REMARKS

Appln. No. 10/085,172
Amendment Dated 12/23/04
Reply to Office Action Dated 08/26/04
ANNOTED SHEET SHOWING CHANGES

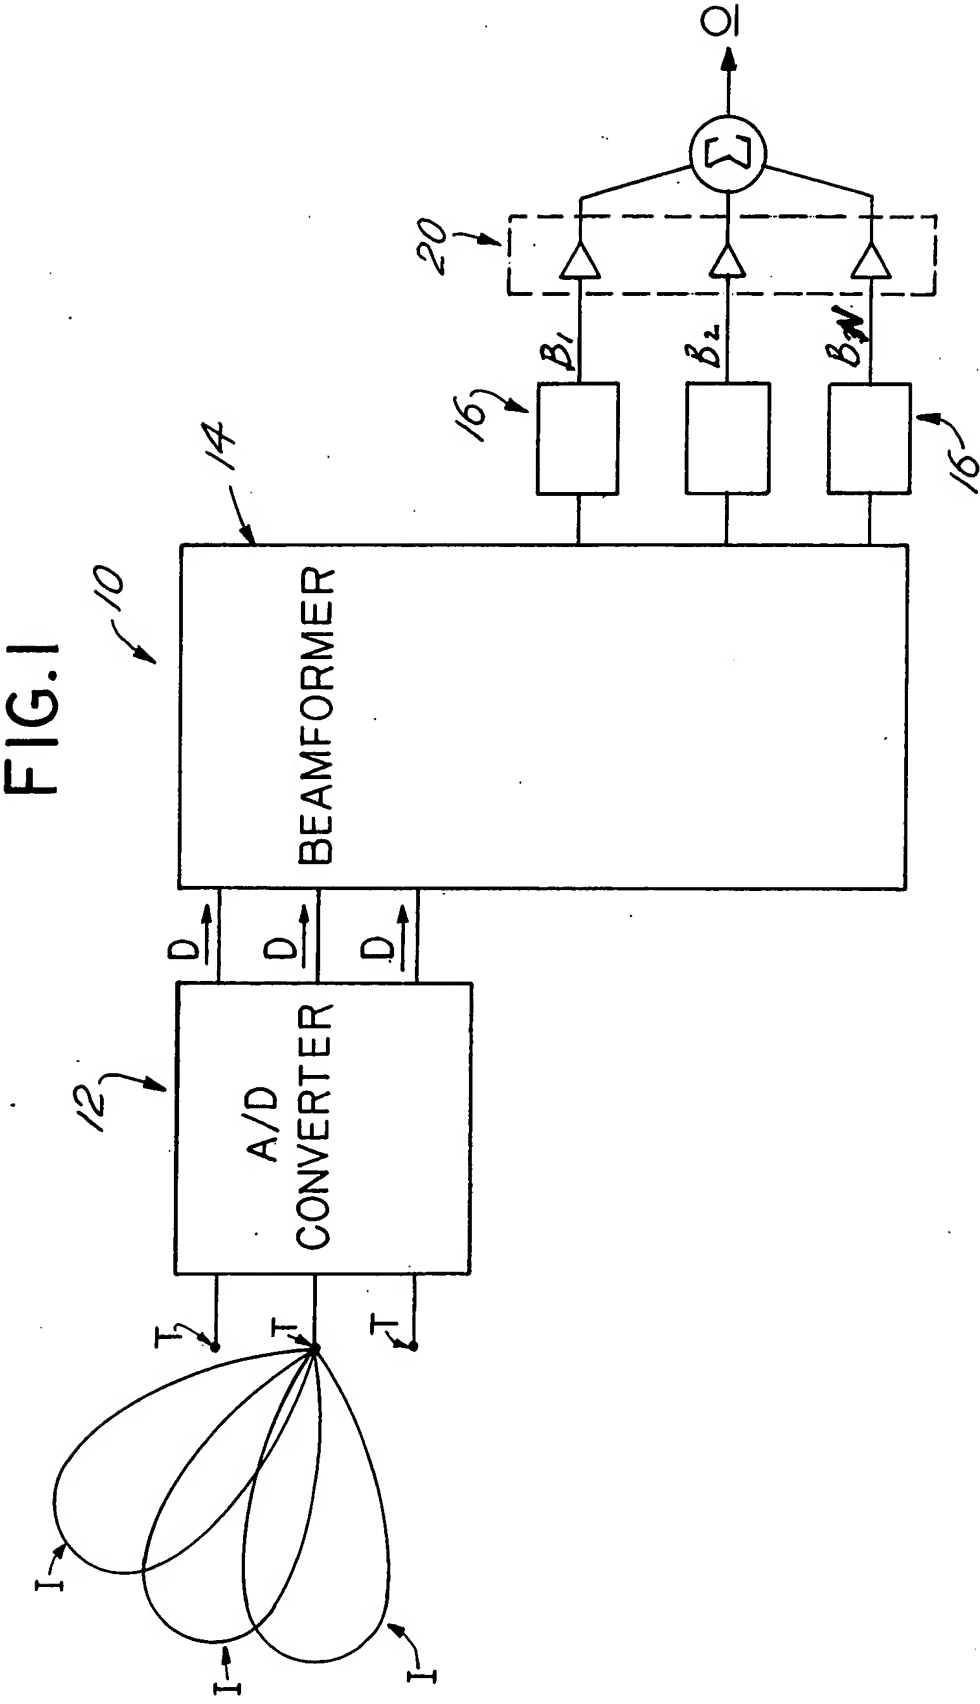
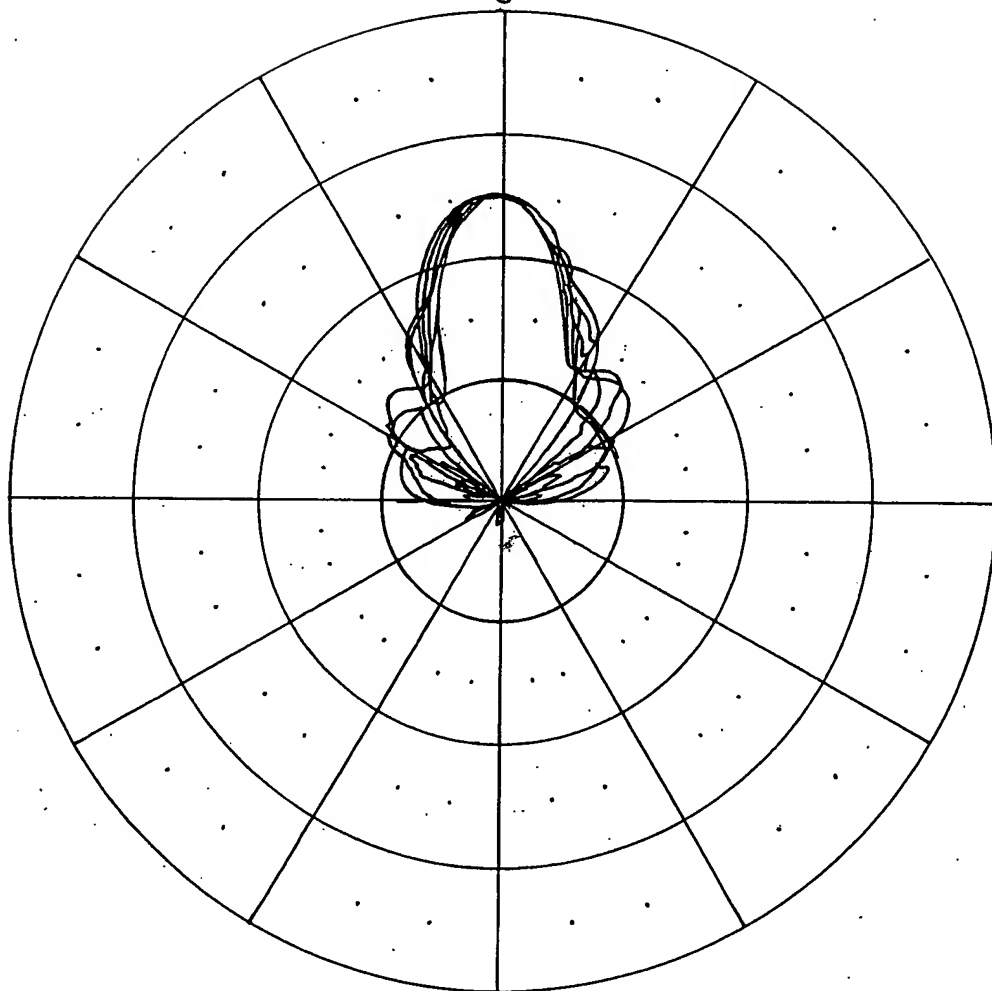
The Applicant is amending Sheet 4 and Sheet 5 (as attached to this paper) to interchange the labels “Fig. 6” and “Fig. 7”. As described in the Brief Description of the Drawings of the present patent application, as originally filed, Fig. 6 is a “polar plot of various frequencies signals **processed** by the present invention” and Fig. 7 is a “polar plot of various frequencies signals **unprocessed** by the present invention”. (Emphasis added.) As amended, Fig. 6 corresponds to the processed signals associated with the unprocessed signals as shown for Fig. 5, and Fig. 8 corresponds to the processed signals associated with the unprocessed signals as shown in Fig. 7. In accordance with the present invention, the beam of the processed signals is narrower than the beam of the unprocessed signals. For example, the present specification, as originally filed, discloses (Page 20, lines 2-8):

Interchanging the labels of Sheet 4 and Sheet 5 is necessary to maintain this relative beamwidth relationship between processed and unprocessed signals.

FIG. 6

~~FIG. 7~~

FIG. 7

~~FIG. 6~~
